TITLE: StemCube Top Prototype 2	REV: 2.0
Company: UMP Stem Lab	Sheet: 1/1
Date: 13/4/2022 Drawn By: Phuah Soon Eu

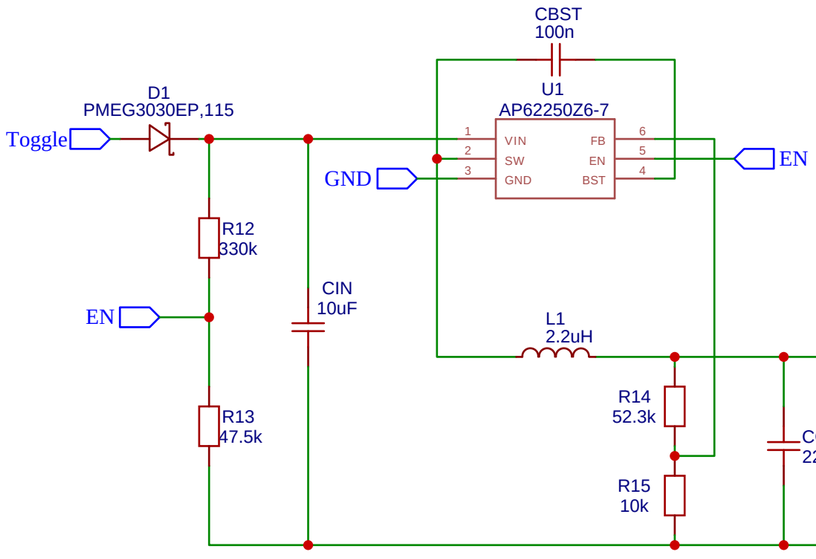
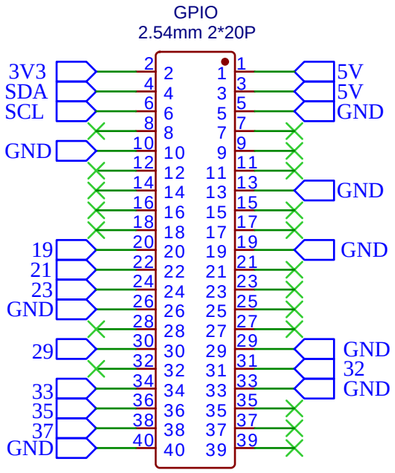
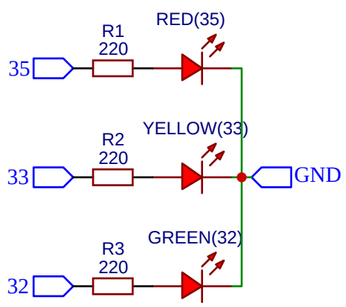
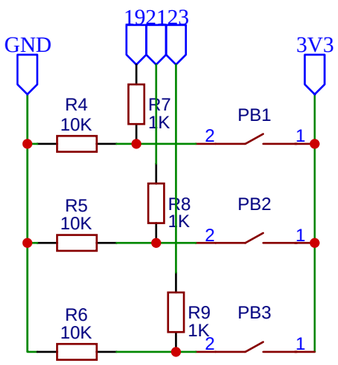
Update Notes
-Switch to AP62250Z6-7 - SOT563 SMPSU
-Include UVLO for PSU Vin
-Include micro USB B input for power brick input
-Include Oring diodes to switch between USB and battery power supply (hotswap)
-Change GPIO pin from BCM to board pins number
-Moved BME280 to Top board
-Changed several pin assignments
-Reworked TOP-BTM Interface: replaced male header with single extended header
-Removed buzzer resistor
